# City of Detroit CITY PLANNING COMMISSION

**RE:** Request of Mariners' Church of Detroit for PC (Public Center) Special District Review of proposed exterior alterations to 170 East Jefferson Avenue – Mariners' Church of Detroit

(RECOMMEND APPROVAL WITH CONDITIONS)

# MASTER PLAN

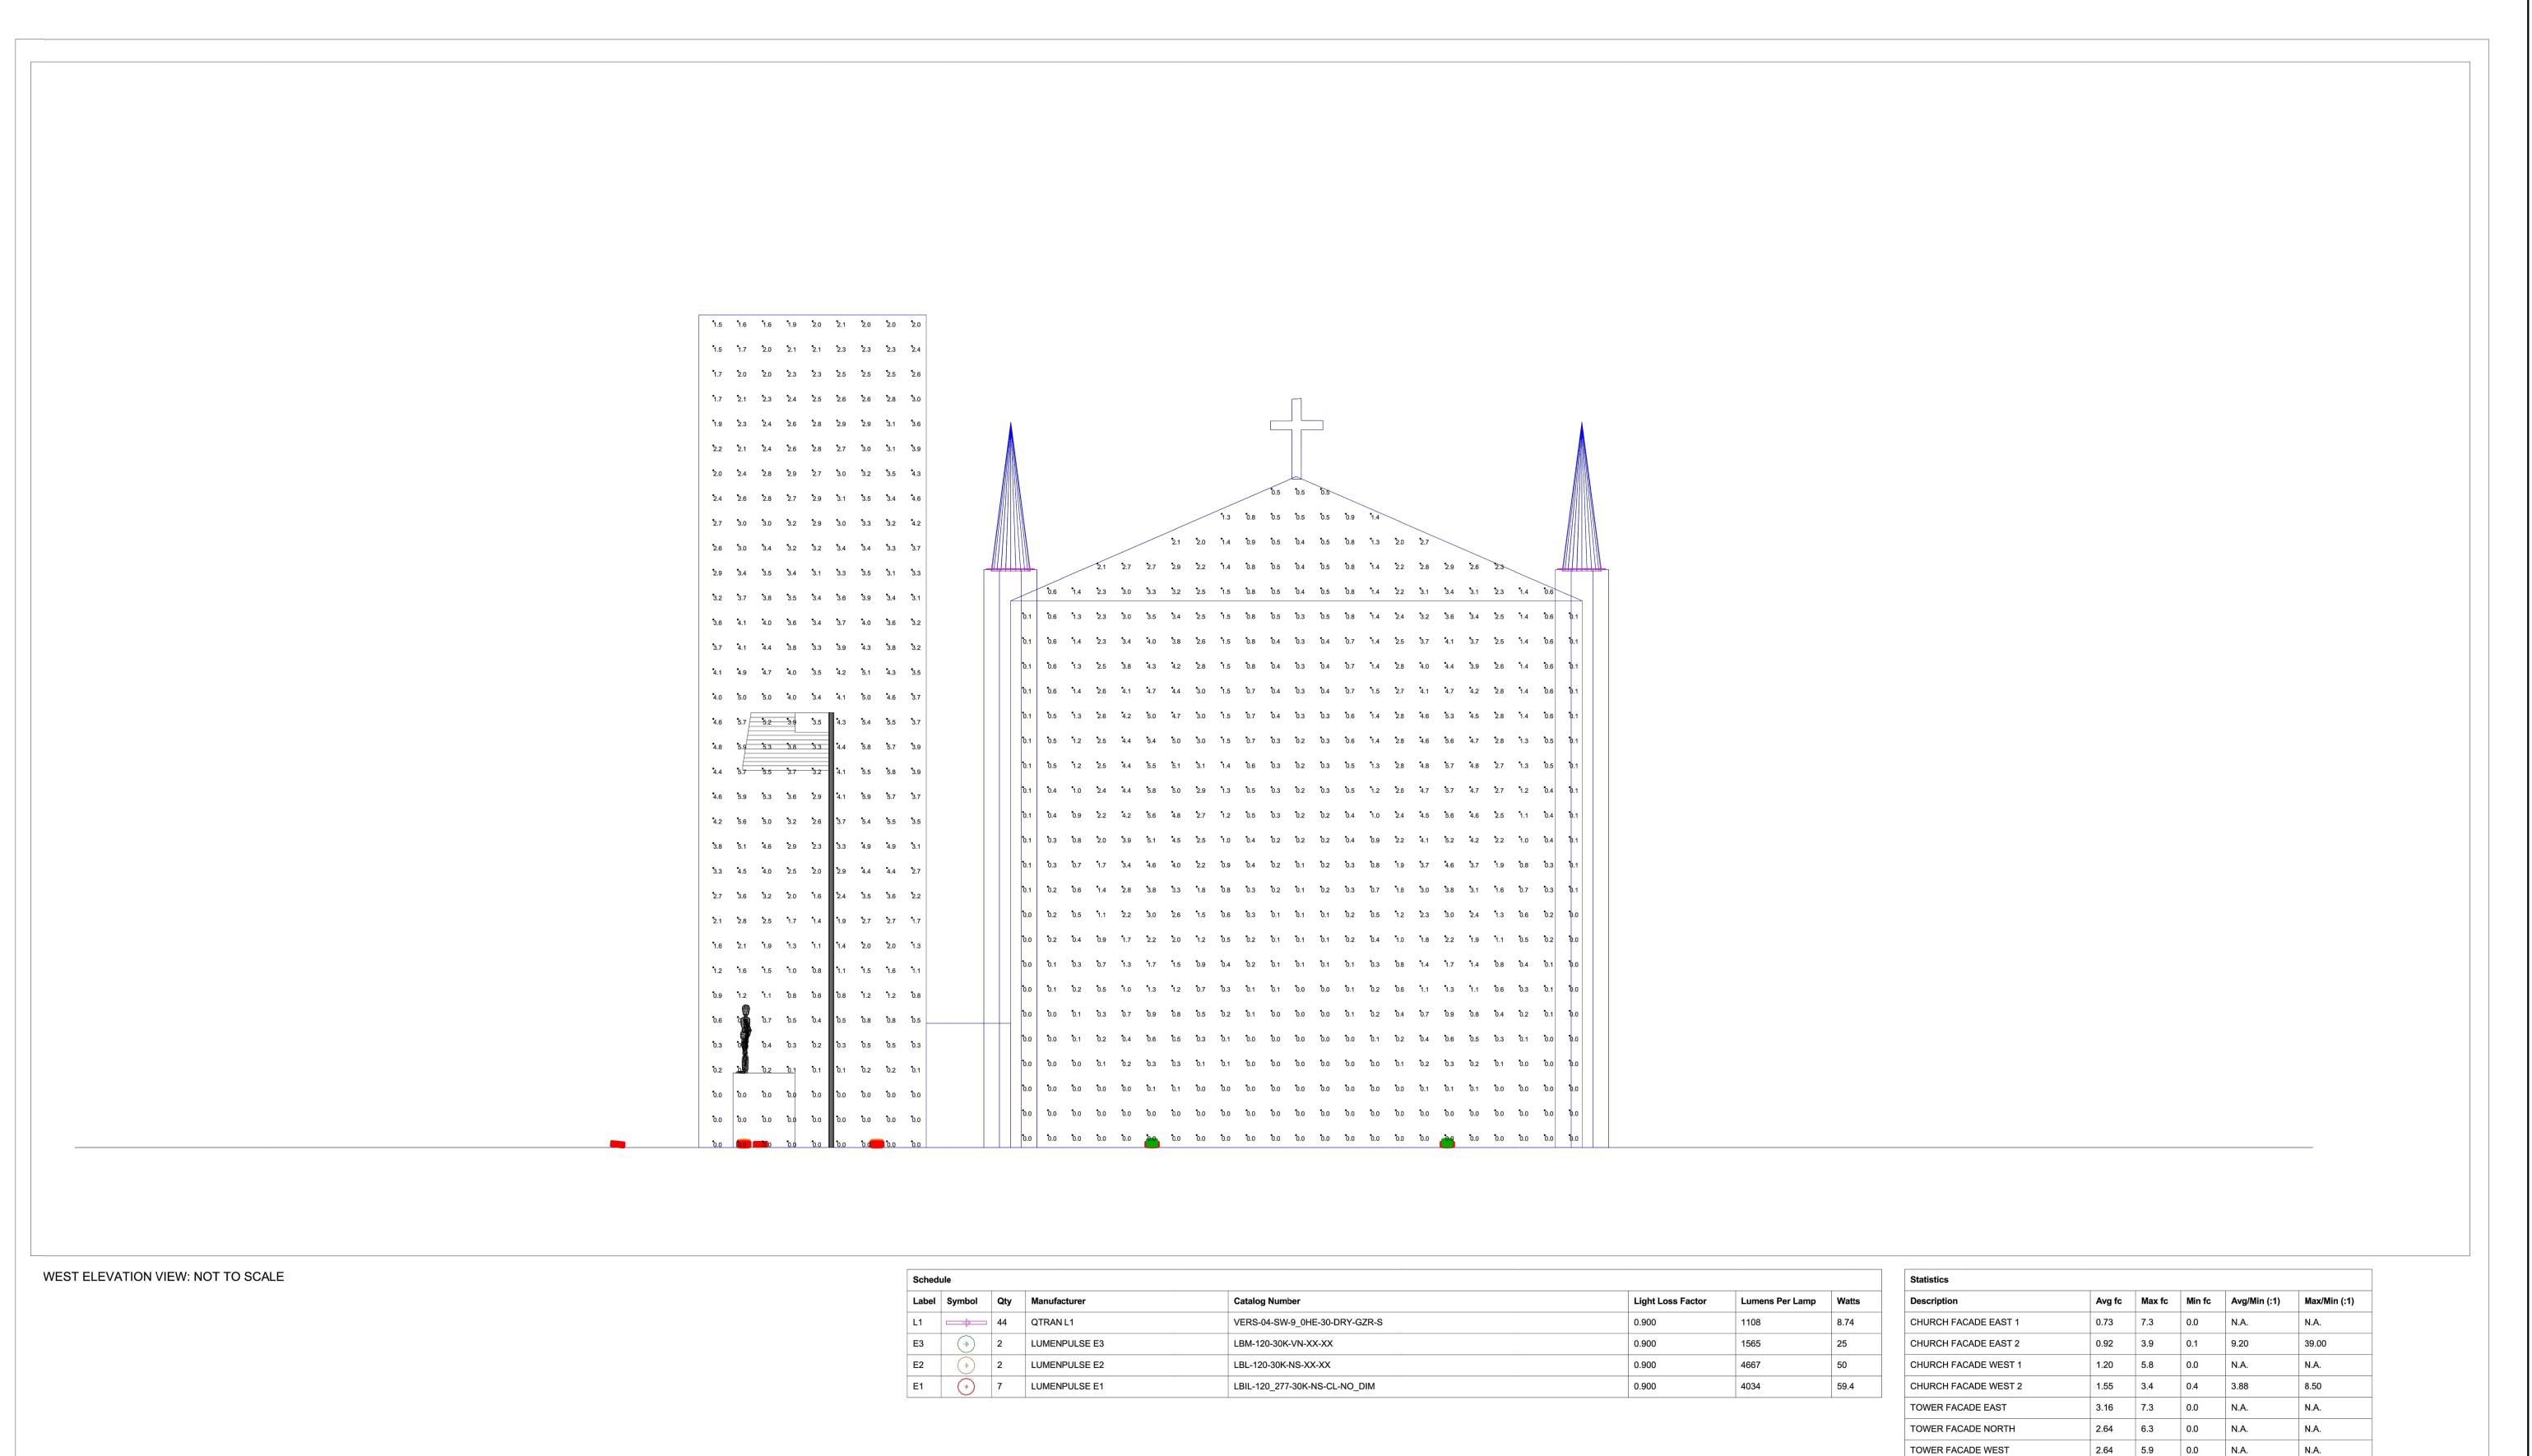
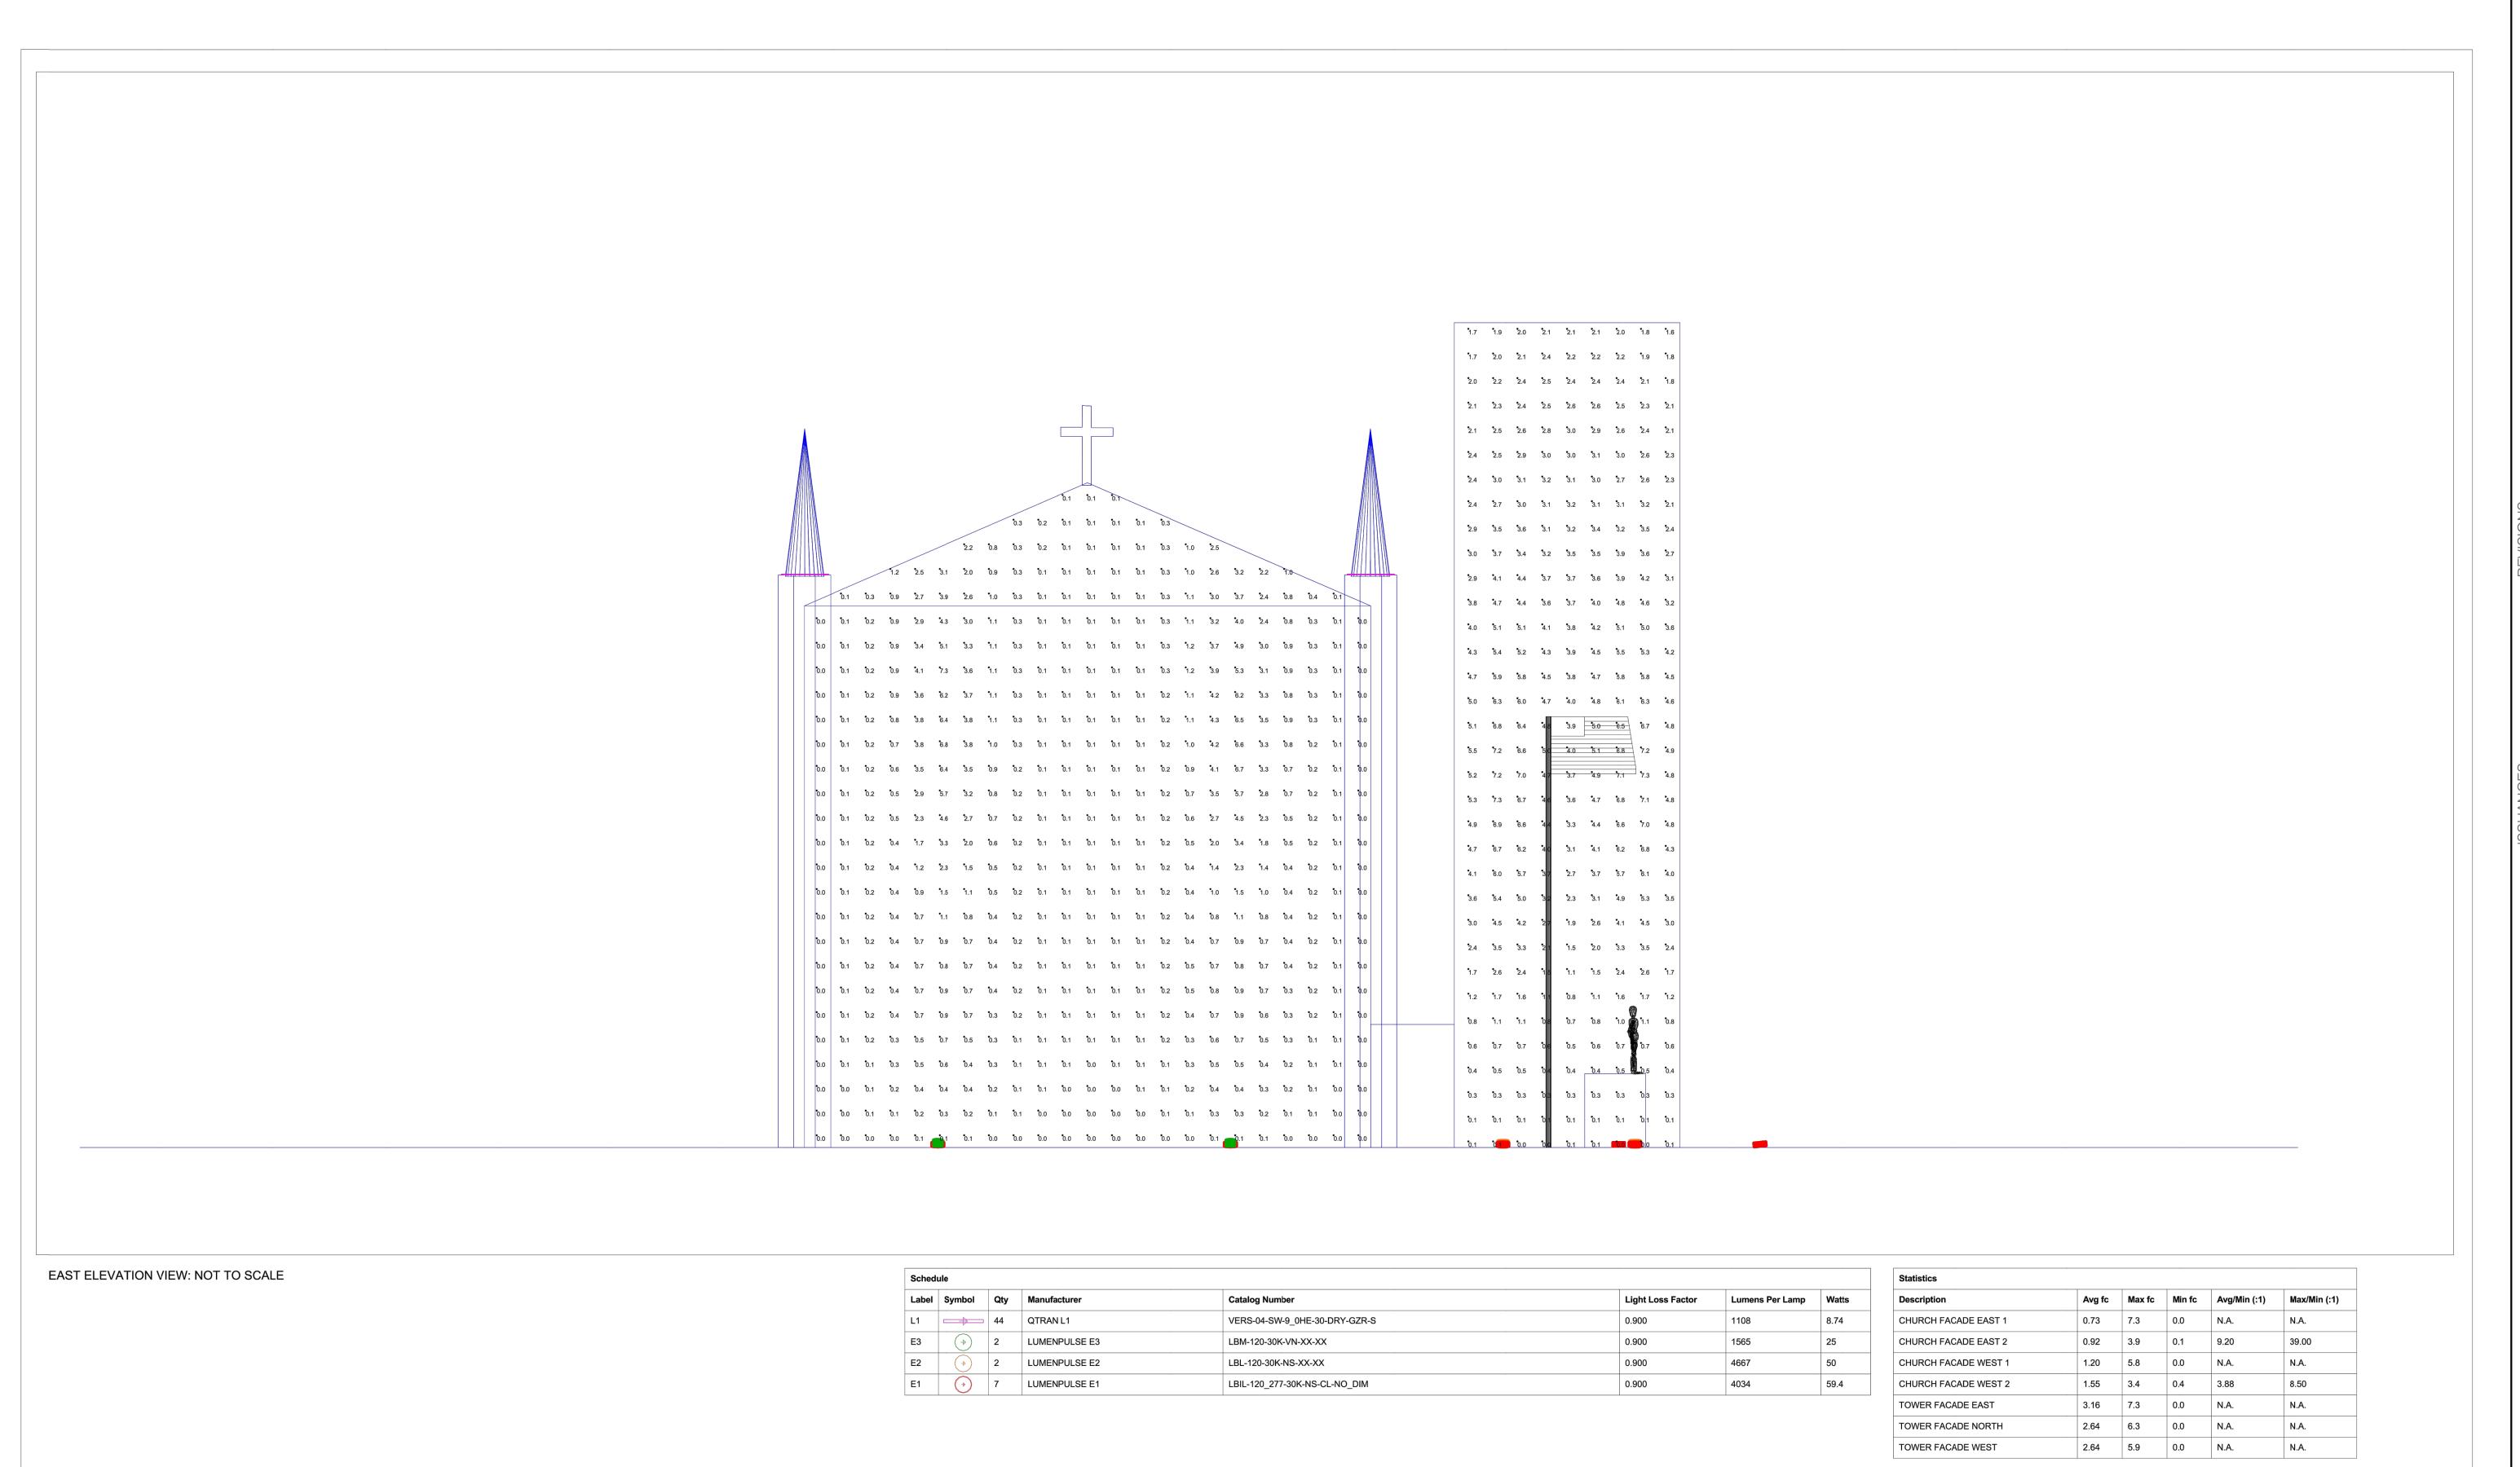
- a. Section 50-14-418 states that all reasonable measures shall be taken to ensure that off-site spillover of light and nightglow are minimized to the greatest extent possible.

- b. CPC staff finds that the revised Site Lighting plan dated July 28, 2022, would take reasonable measures to limit light spillover and nightglow as illuminance levels depicted on sheets A106, A108, and A110 indicate that the highest levels of illuminance would be focused on building facades, the tower, and pinnacles, and would not be focused off-site or directly into the sky. Additionally, there are numerous examples of buildings, especially churches, located within the Central Business District that have similar focused up-lighting provided.
